Alameda Point - Site A • Waterfront Park • PHASE I

PLANNING BOARD: DESIGN REVIEW AMENDMENT | DECEMBER 09, 2019

Alameda Point - Site A:
Waterfront Park Phase I
Substantial Conformance Exhibits

PROPOSED SITE PLAN CONCEPT

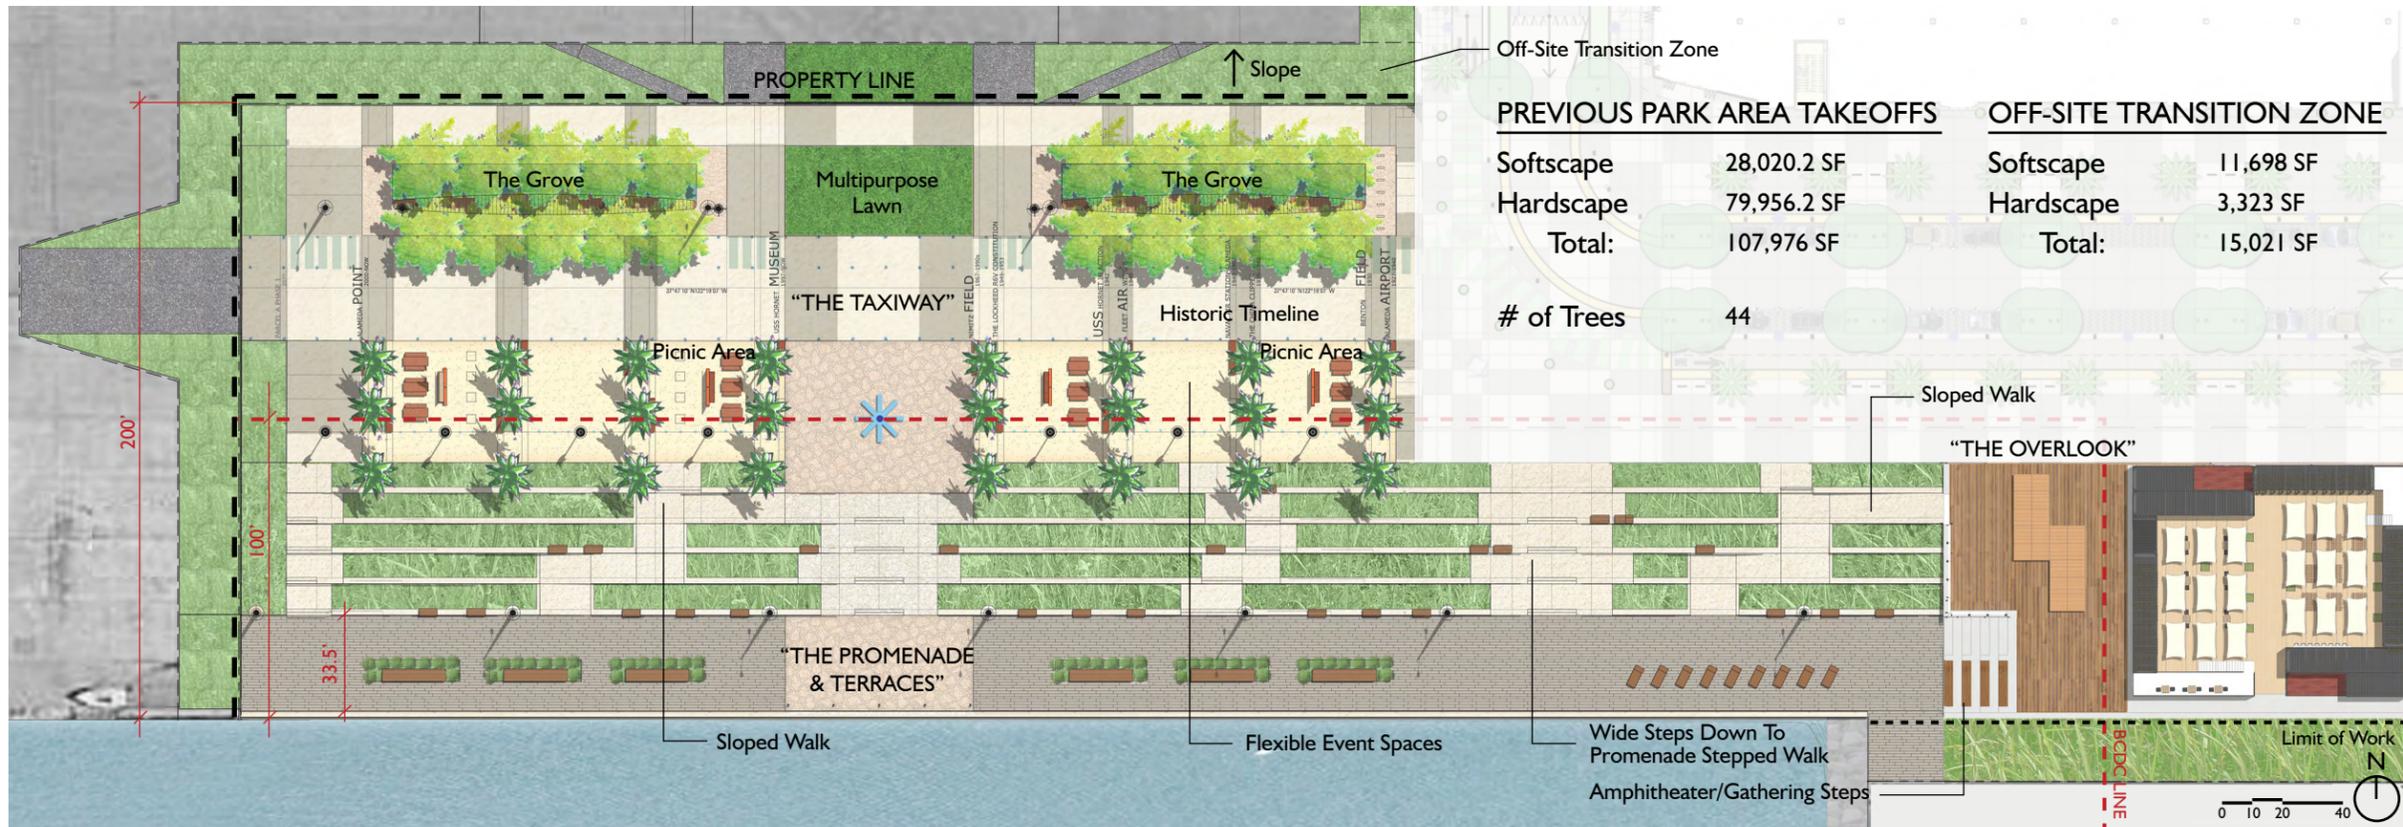
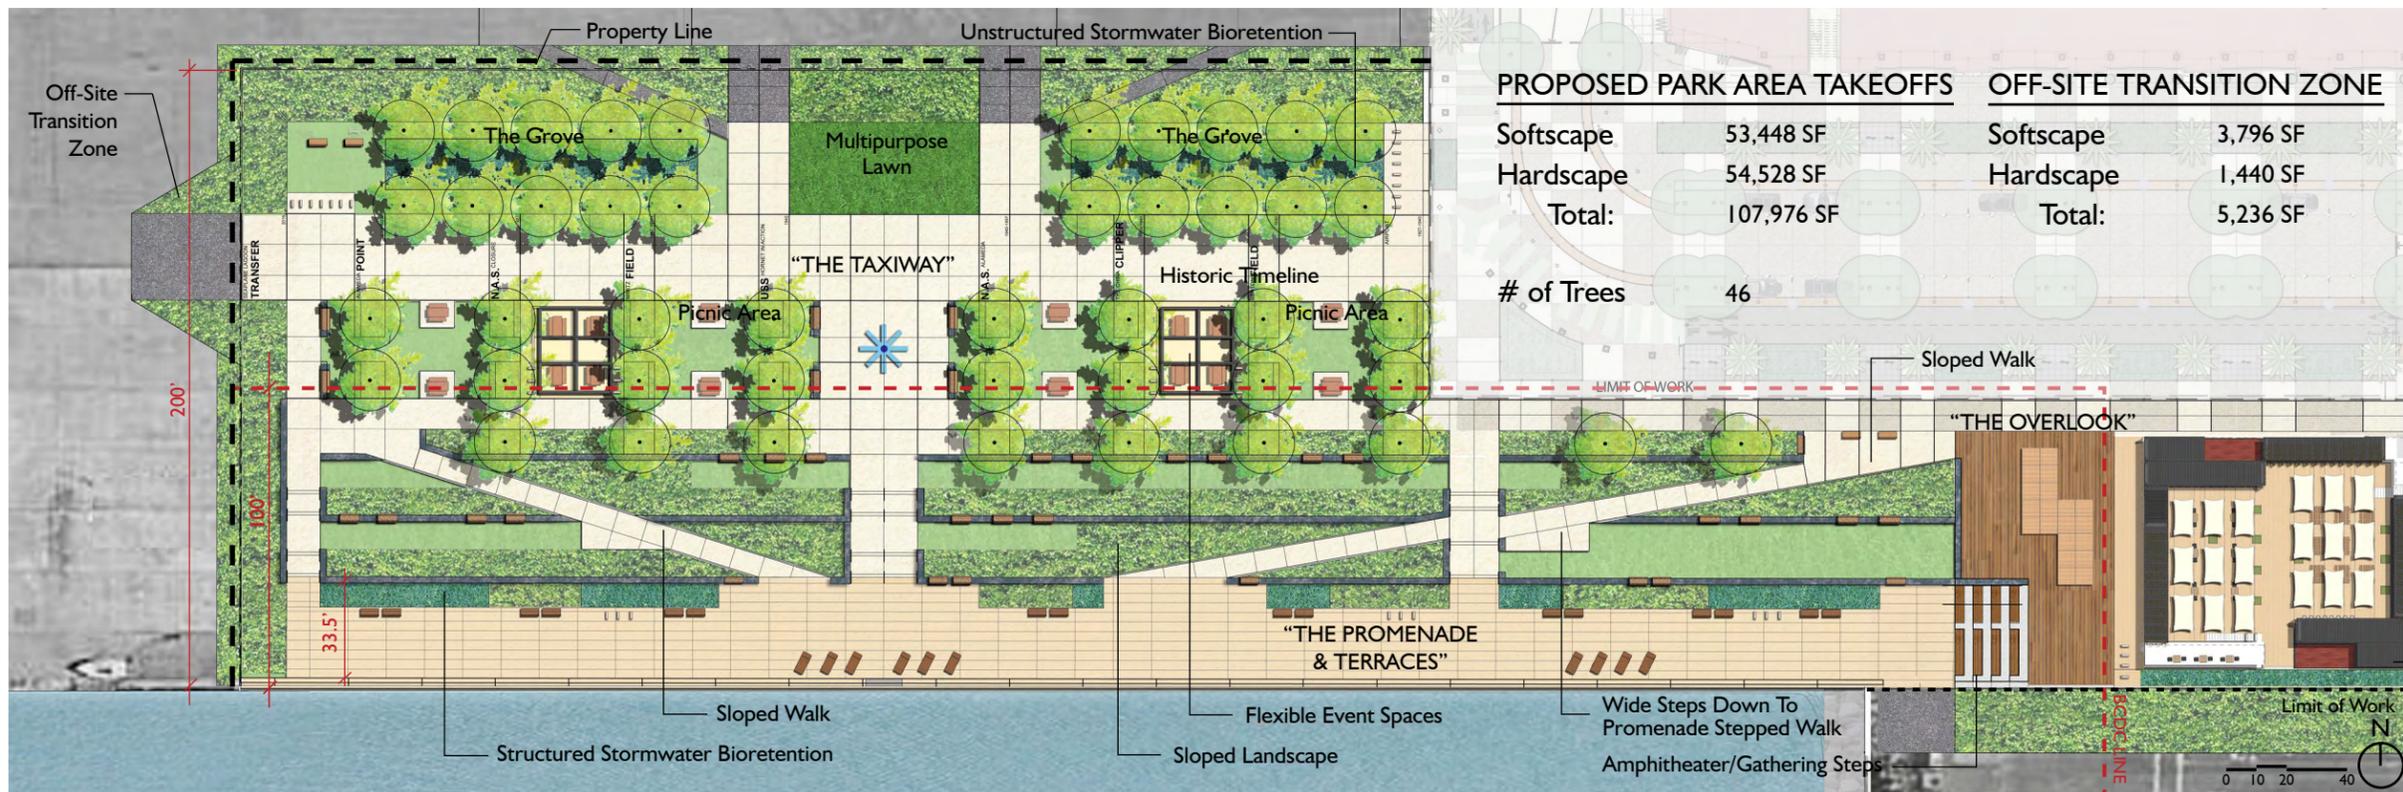
PREVIOUS SITE PLAN CONCEPT

SECTION A: Through Proposed Plan

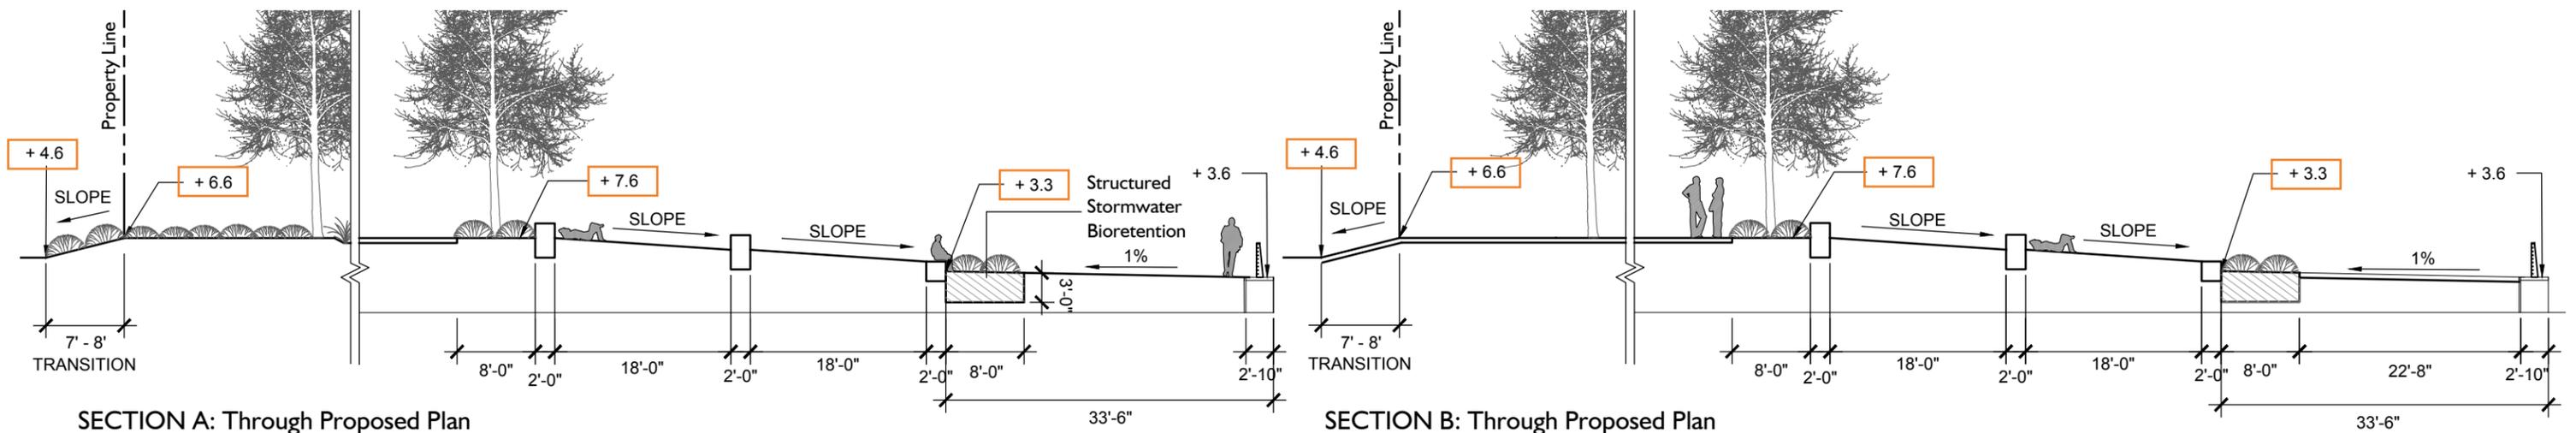
SECTION A: Through Previous Plan

SECTION B: Through Proposed Plan

Purple Robe Honey Locust
Robinia 'Purple Robe'

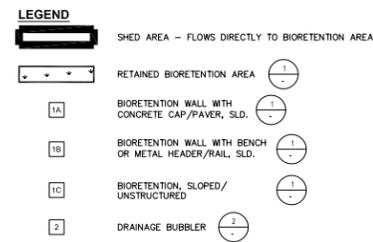
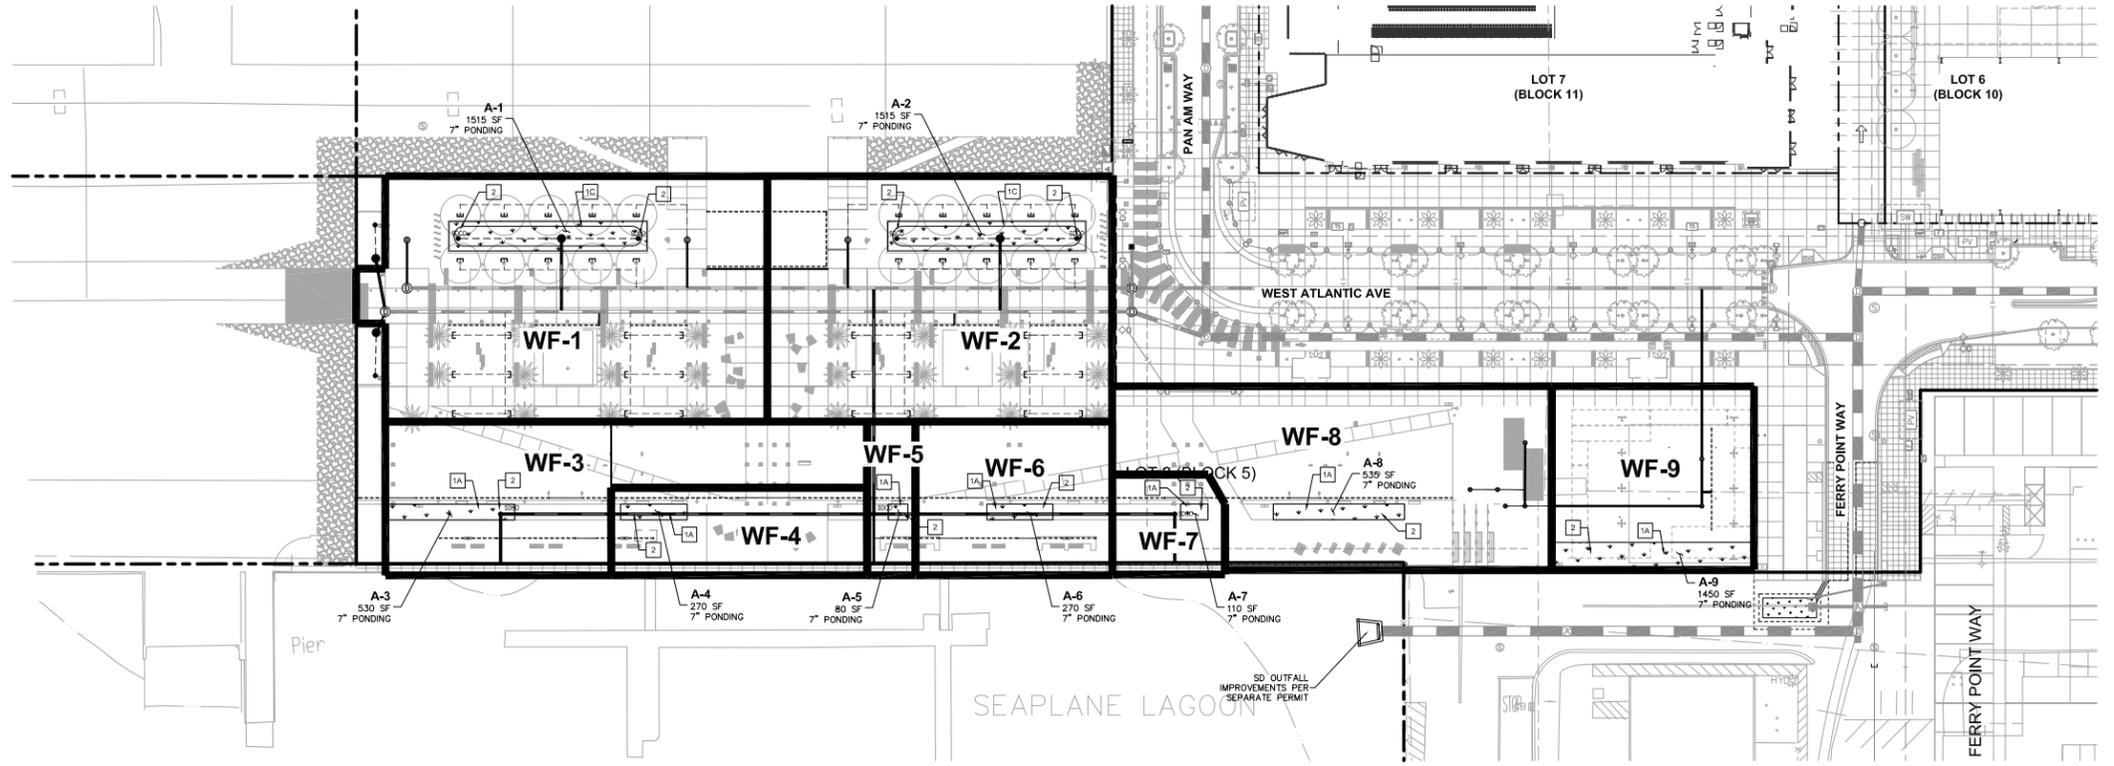
WAS THIS:

Mexican Fan Palm
Washingtonia Robusta

Washingtonia robusta
Mexican Fan Palm:

- These palms are completely suited to the coastal climate
- These palms are readily available in the quantities that we need for the Waterfront Park, but also additionally for the Shared Street and West Atlantic Drive
- They are very affordable
- These palms grow to be too tall for human scale, ultimately 90-120 feet
- They grow at 2 feet per year, so in 20 years they will be 60 feet tall

NOW THIS:

Robinia 'Purple Robe'
Purple Robe Honey Locust:

- Will grow 30 - 40 feet high and 20 - 30 feet wide
- Excellent shade tree
- Has deciduous foliage
- Drought tolerant
- Suitable for seaside regions
- Fragrant flower
- Fall color
- Tree selection for Orion Street at Alameda Point
- Native
